## ADDENDUM No. 3

### RFP No. 26-11

#### N. University and Thayer Improvements

SHEET No. 14 OF 80

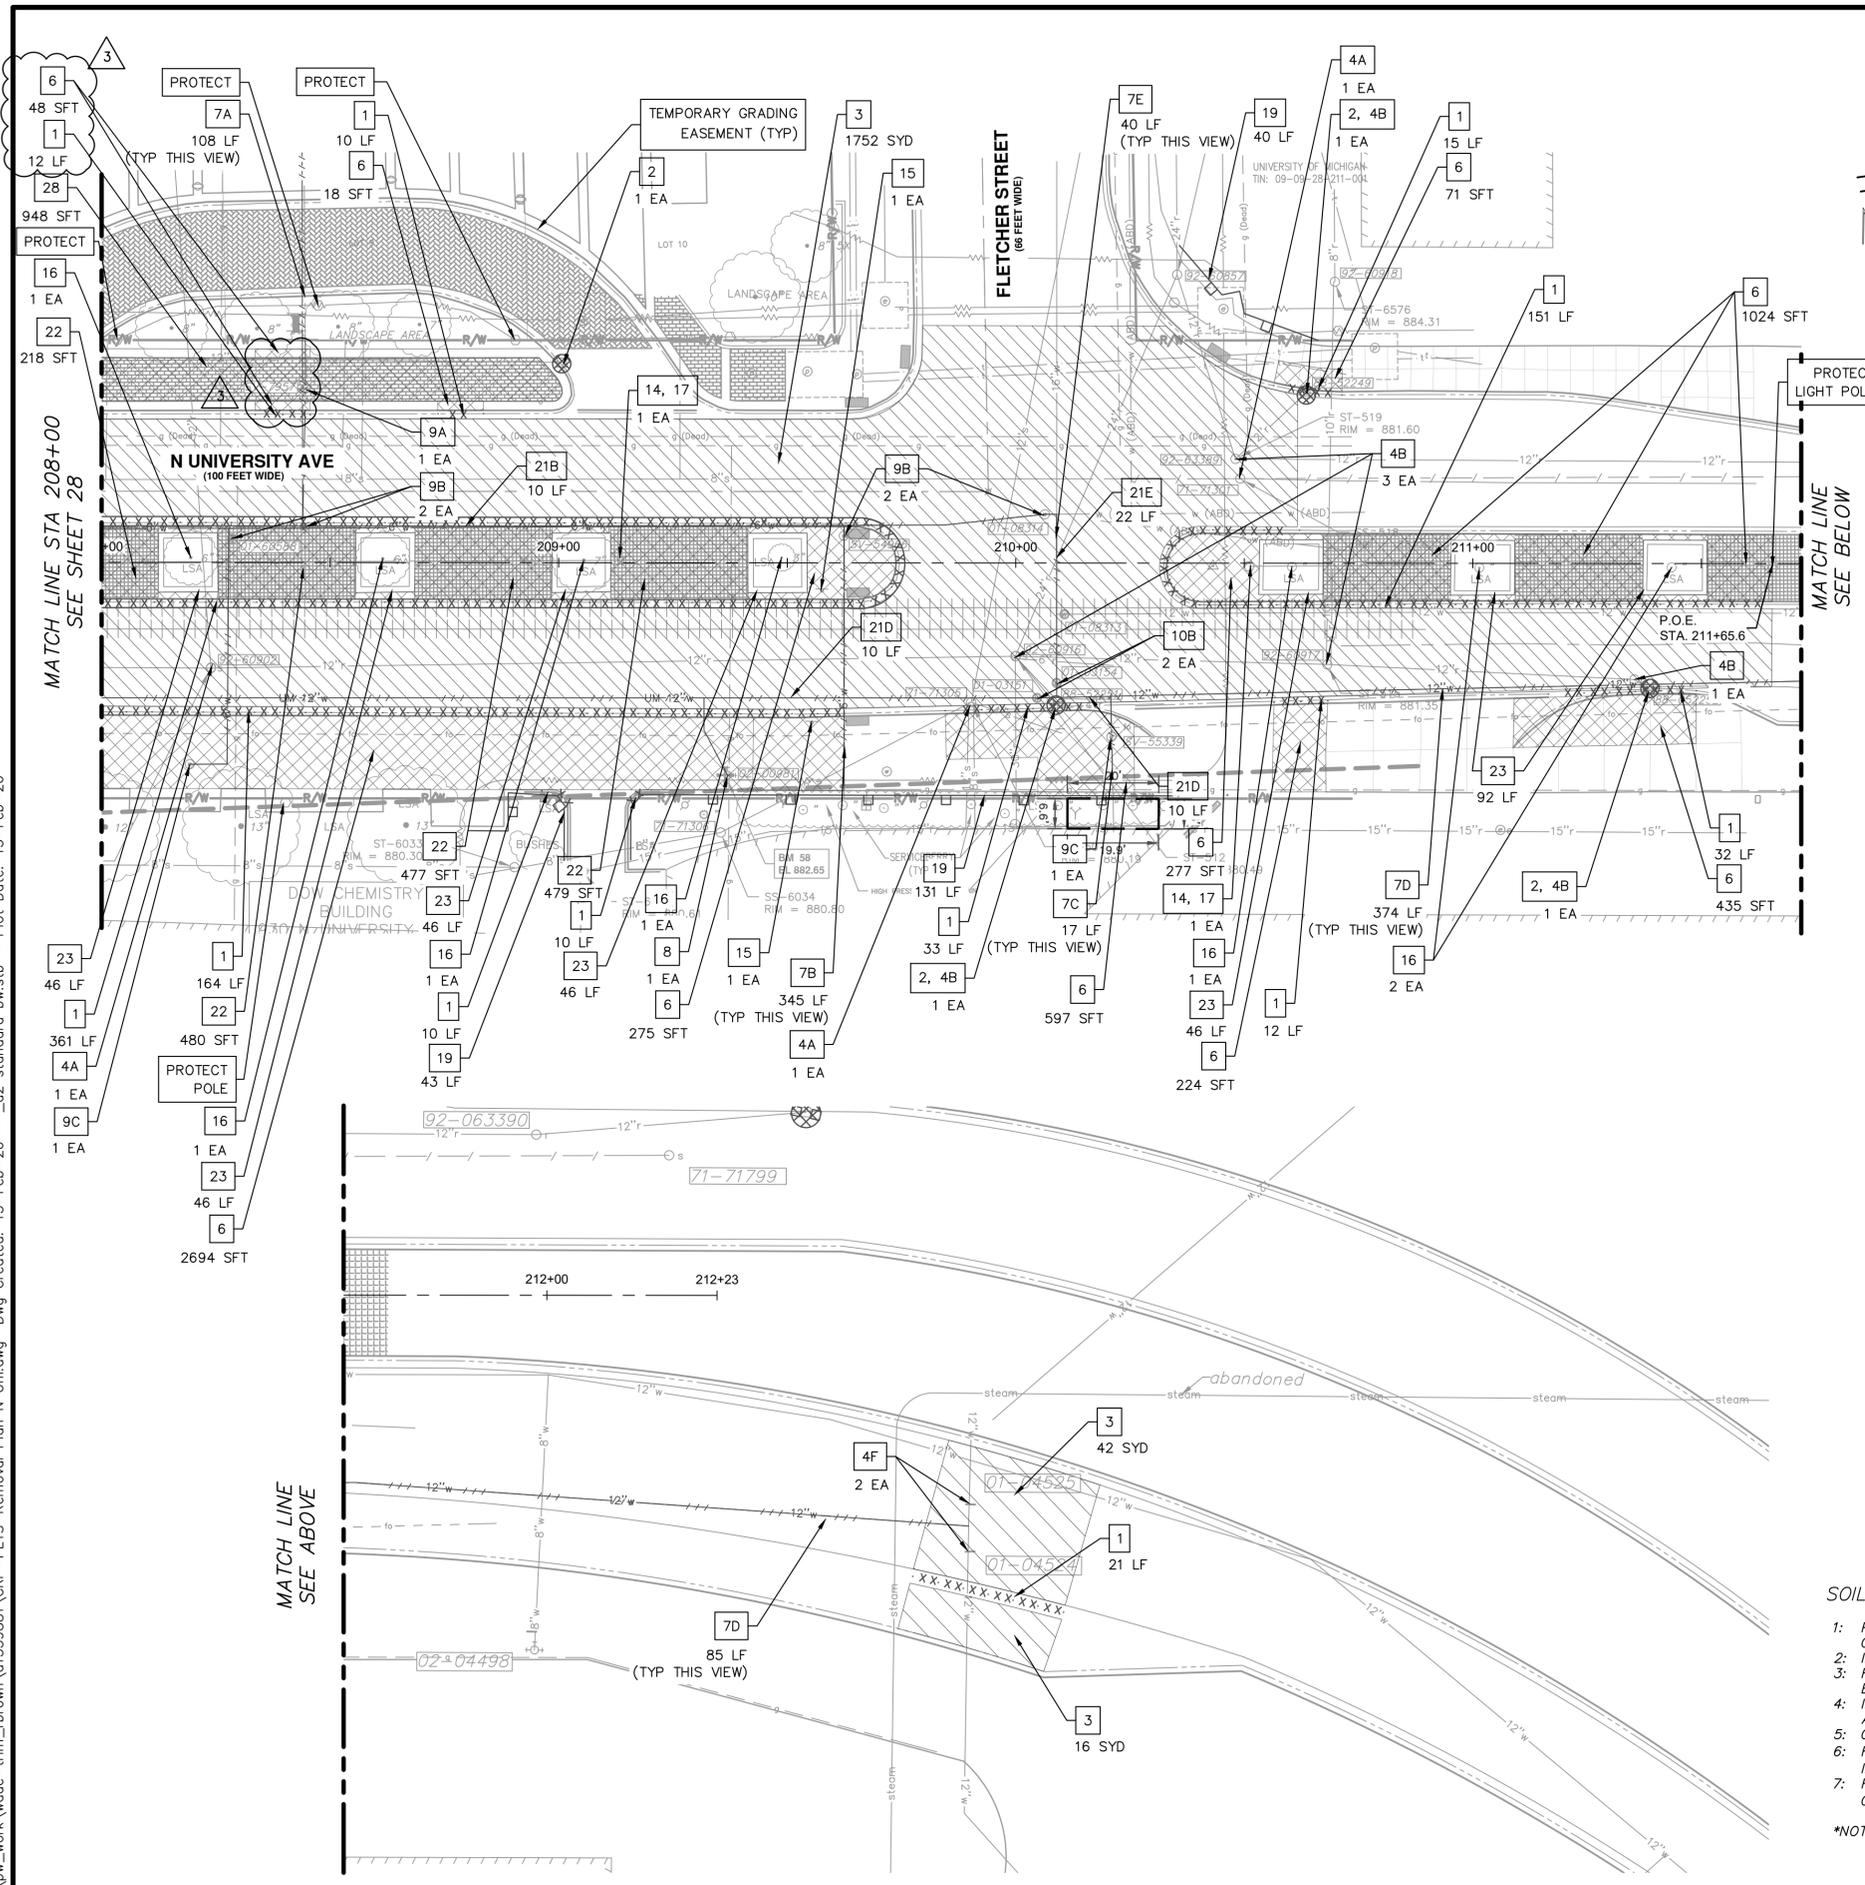
| <b>Section/Page(s)</b>                                     | <b>Change</b>  |
|--|--|
| Plan Sheet 14  | Revision of layout of proposed planter boxes in the North University median. |

SHEET No. 29 OF 80

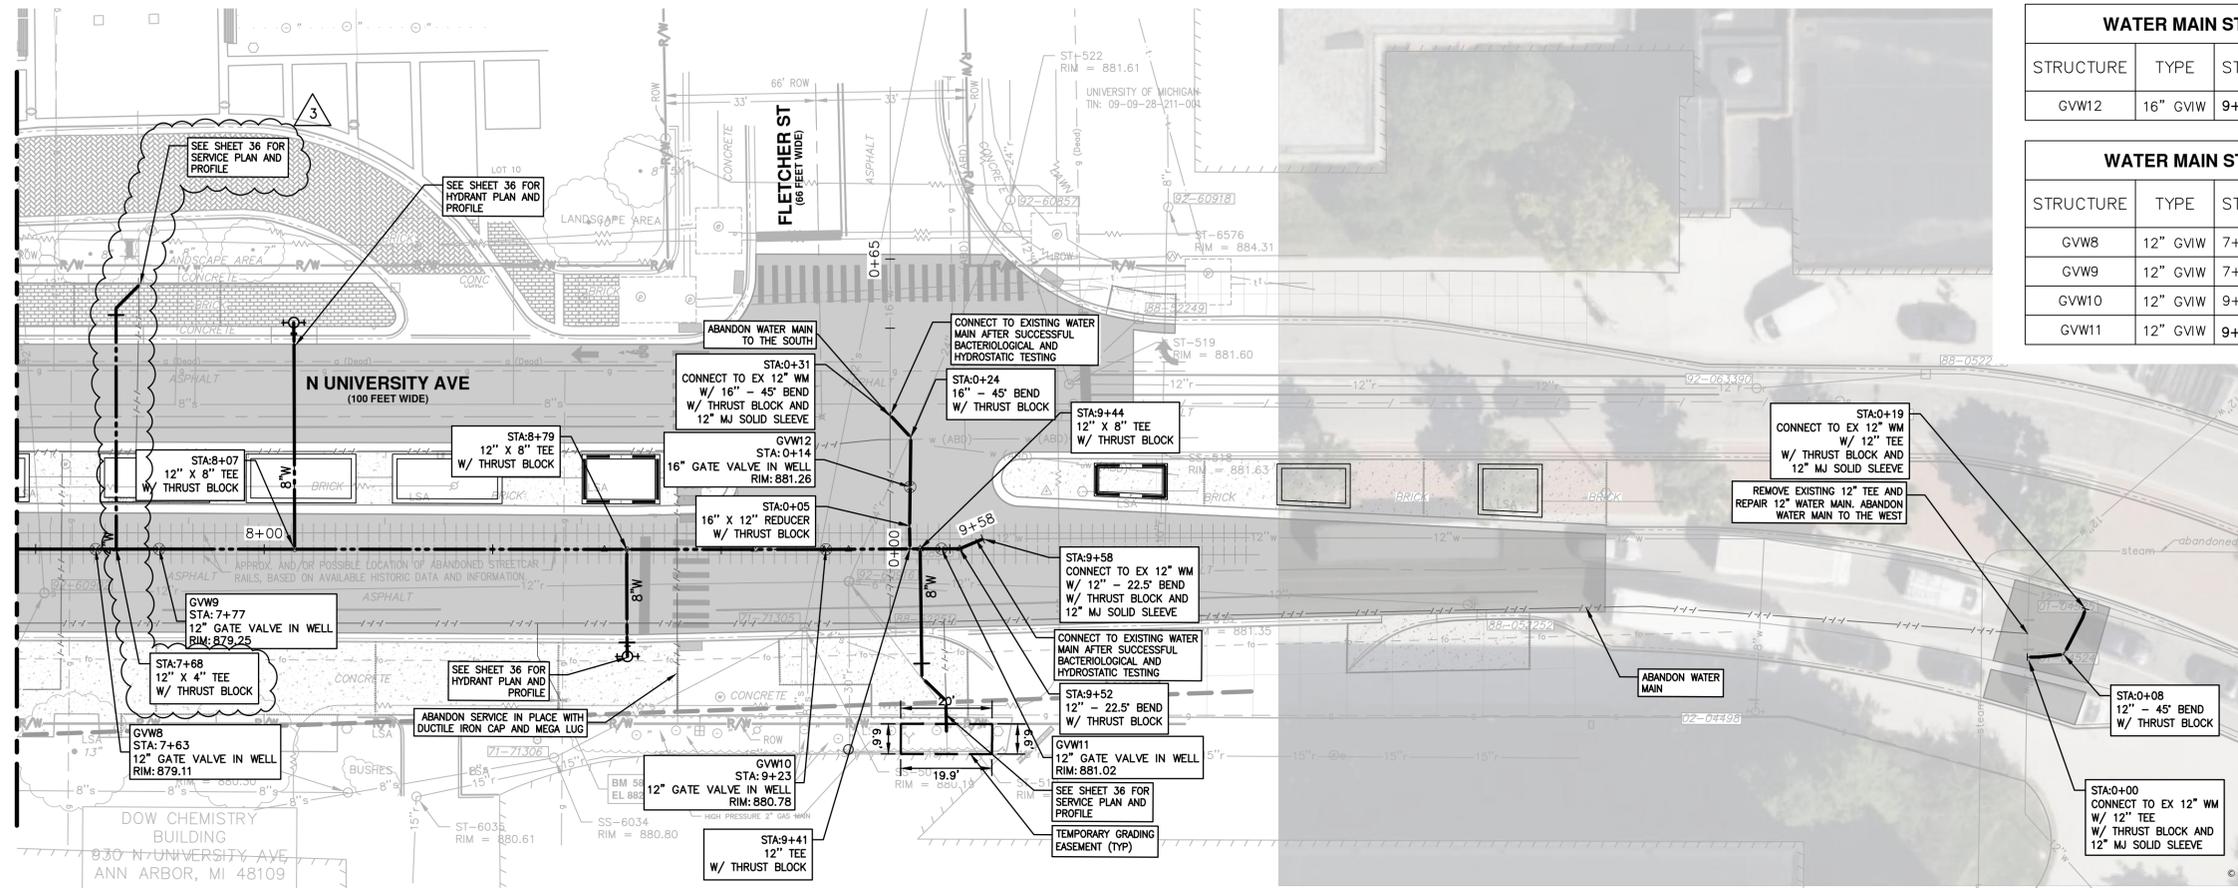
| Plan Sheet 29     | Revisions made to water service lead to Michigan League building.                       |

SCALE: 1"=20' VERTICAL 1"=4'  
DRAWING NO. 2023-023-33

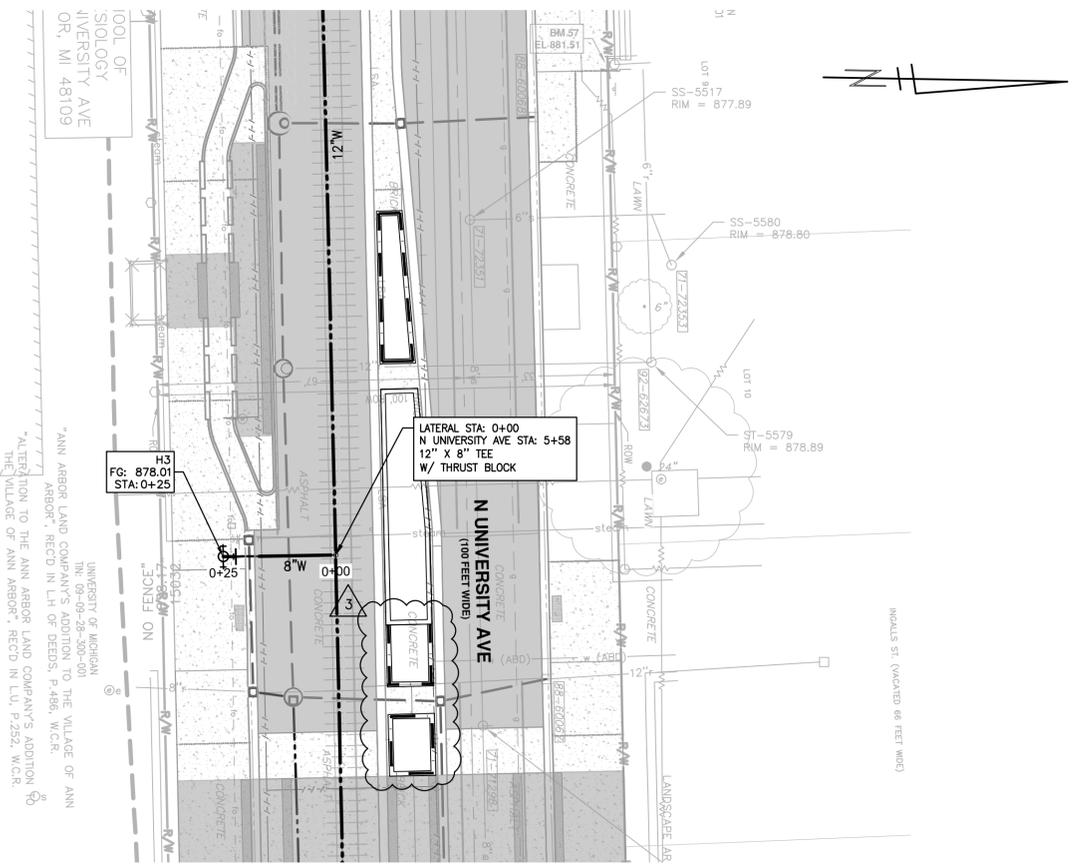
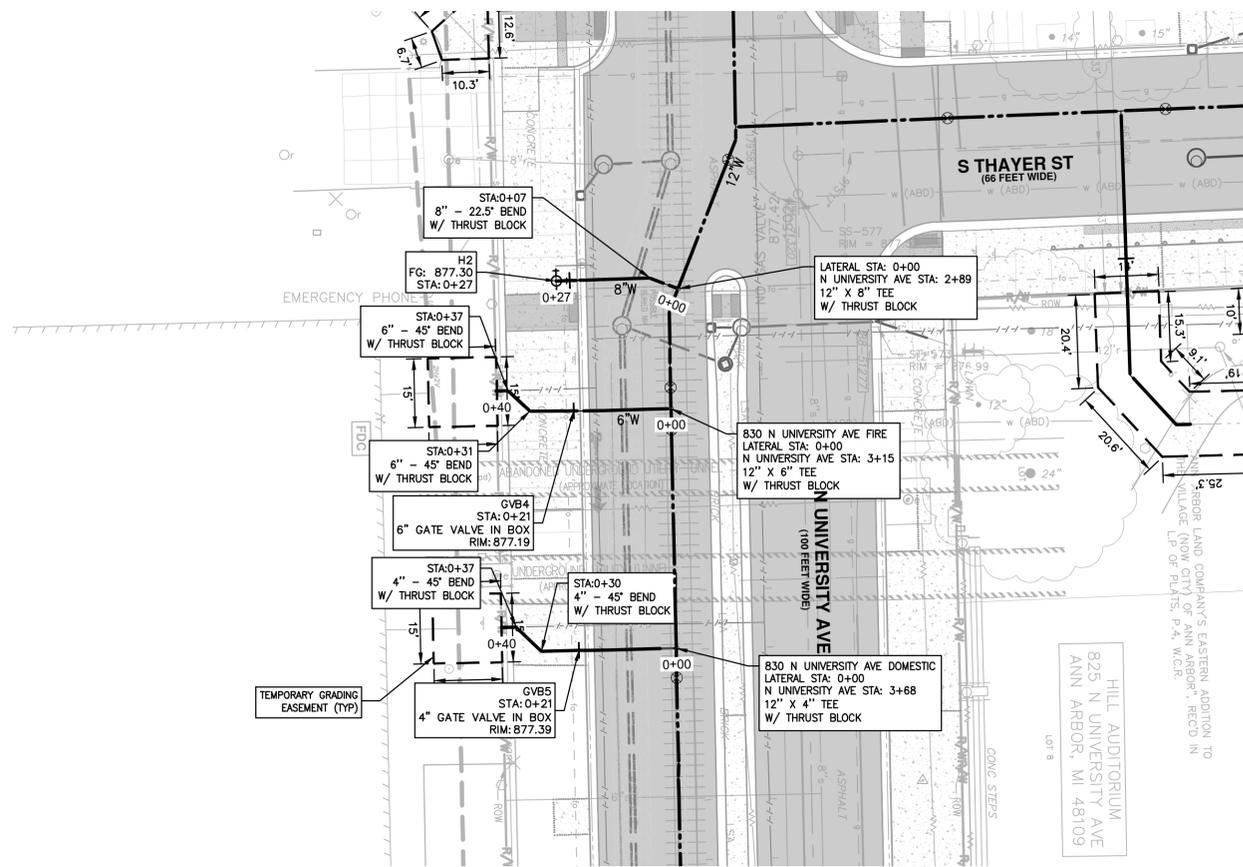
| Plan Sheet 33     | Revisions made to water service lead to Michigan League building.                       |

DRAWING NO. 2023-025-36  
SHEET NO. 36 OF 80

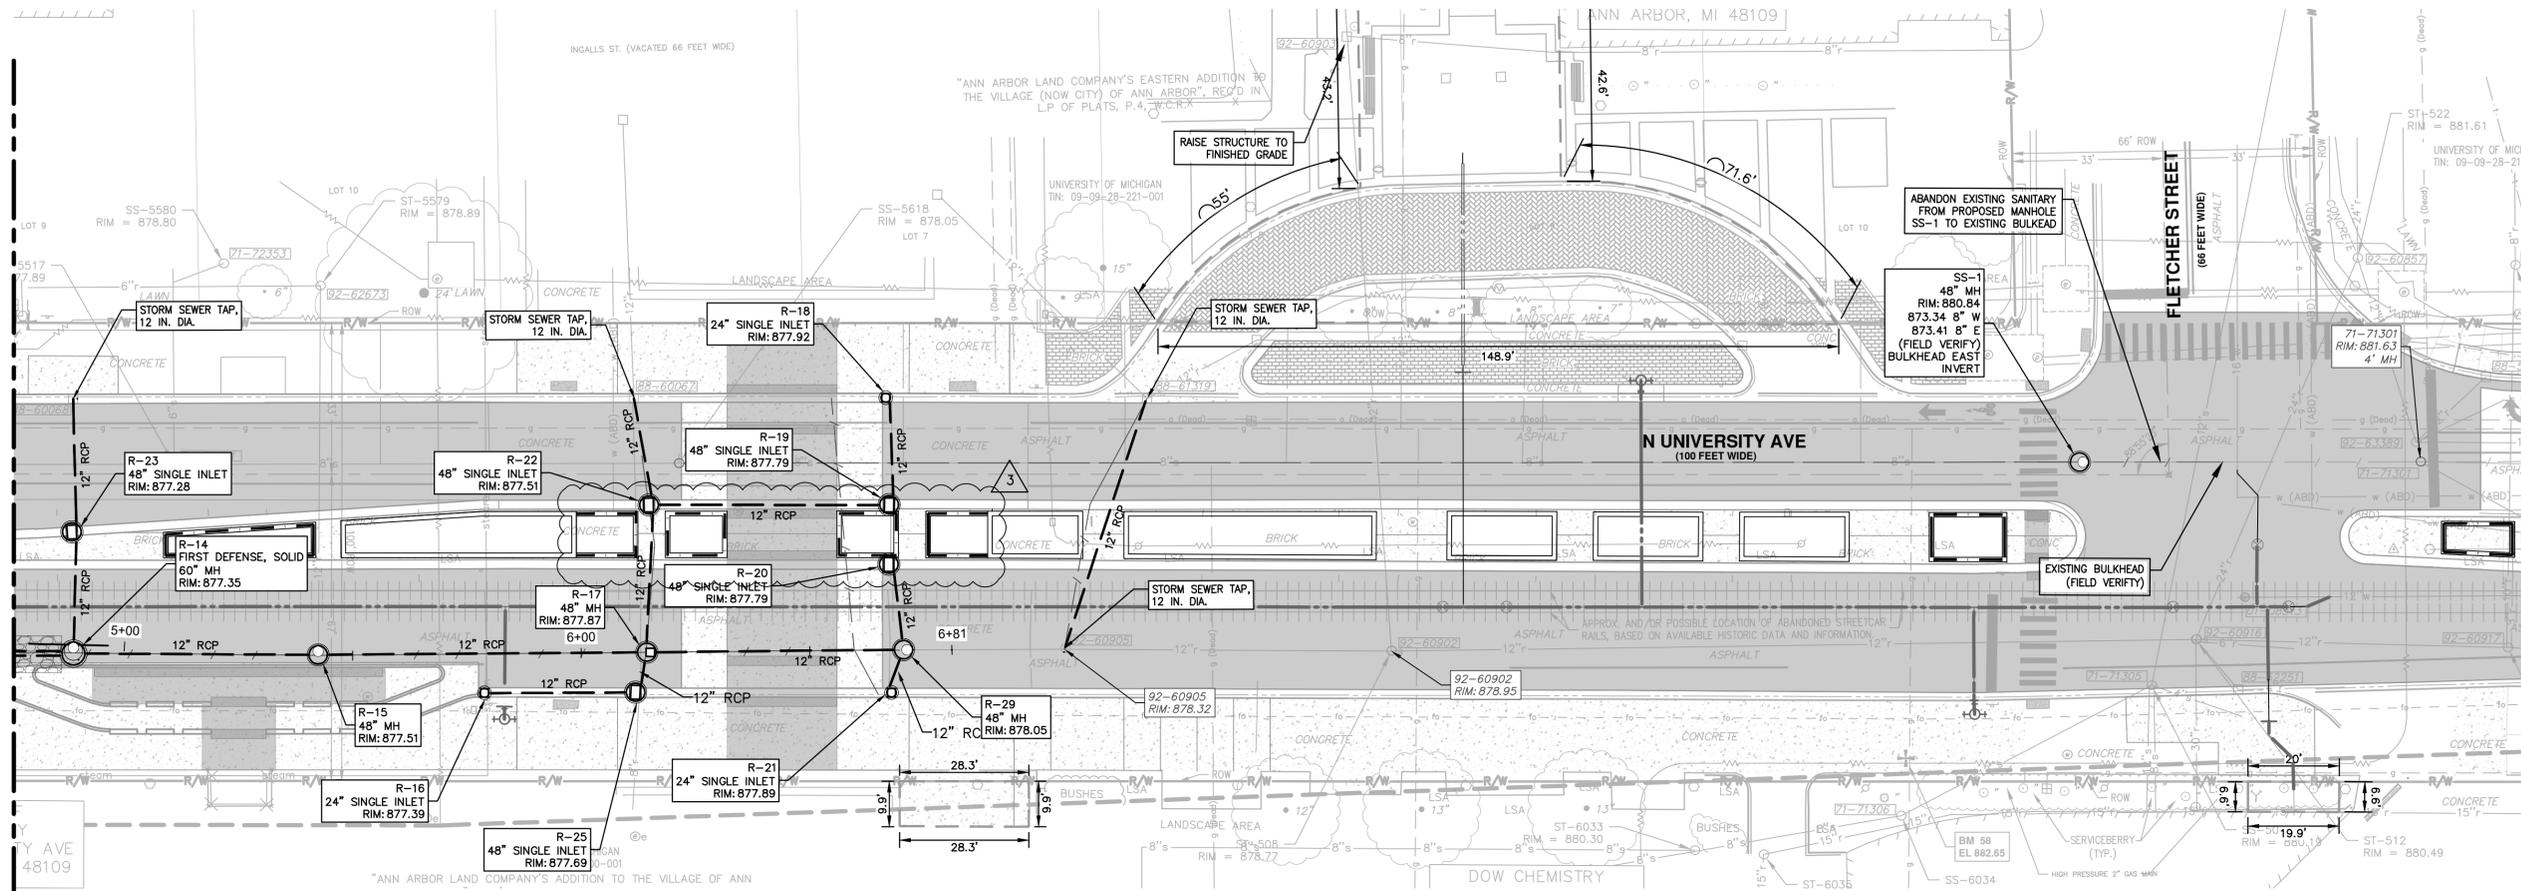
| Plan Sheet 36     | Revisions made to water service lead to Michigan League building.                       |

SCALE: 1"=20'  
DRAWING NO. 2023-023-40

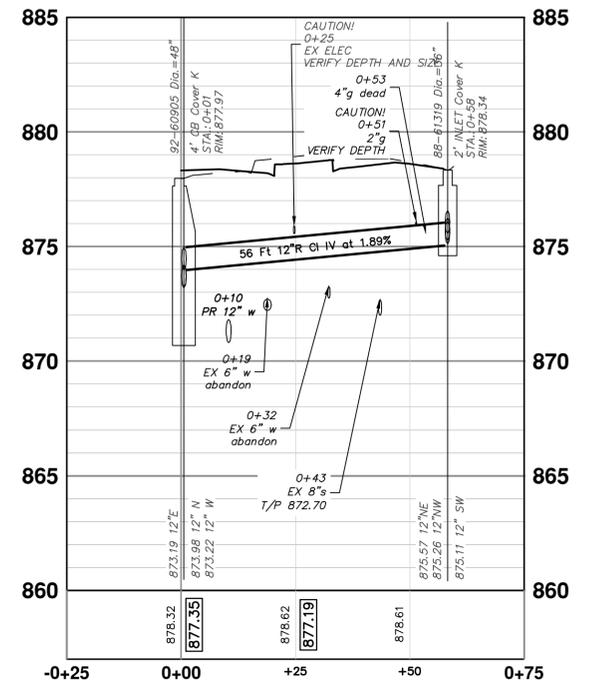
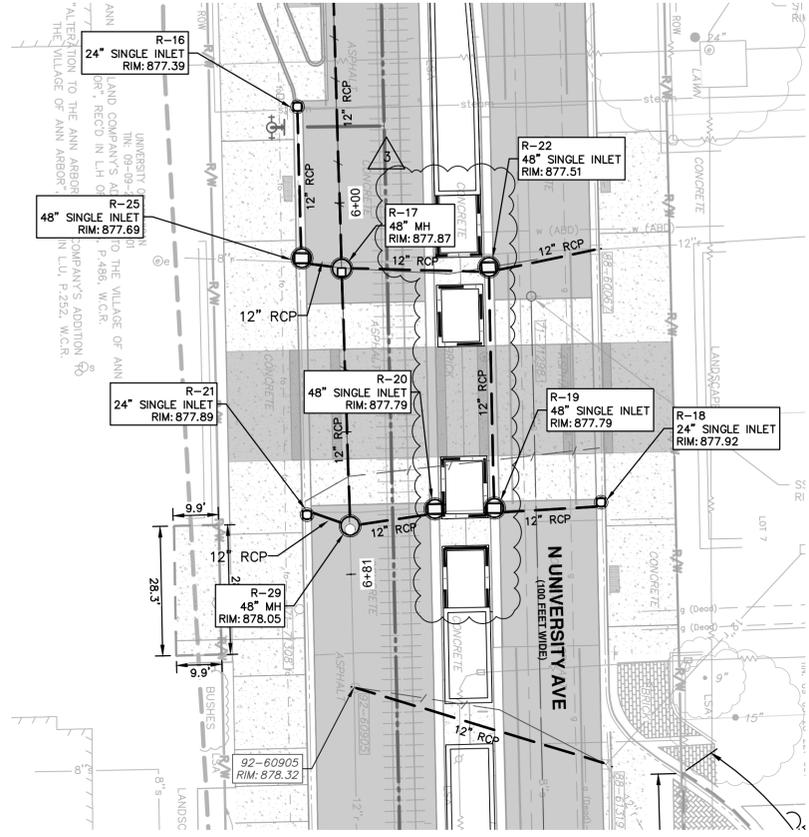
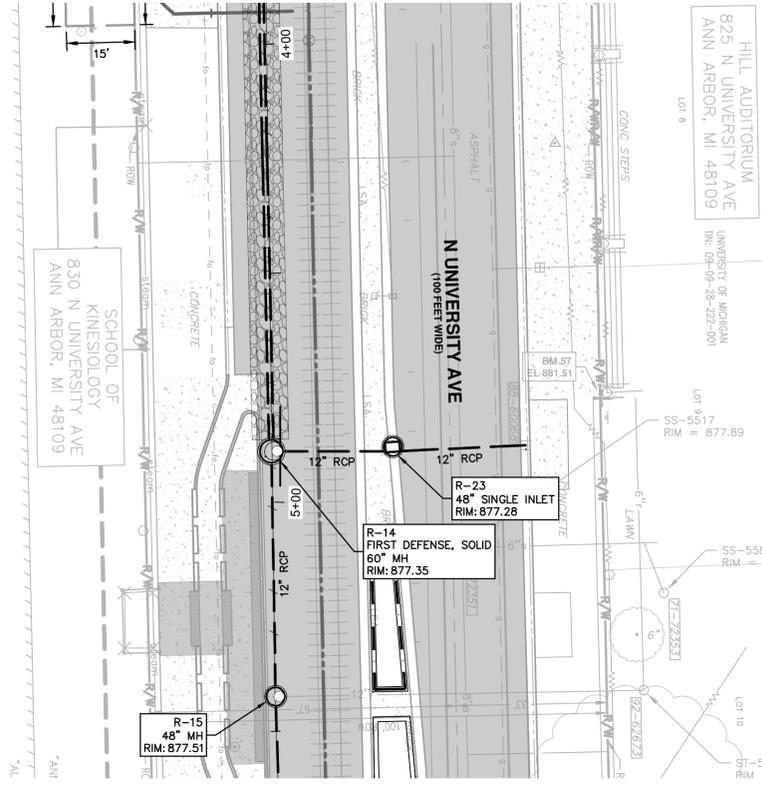
| Plan Sheets 40    | Revision of layout of proposed planter boxes.   |
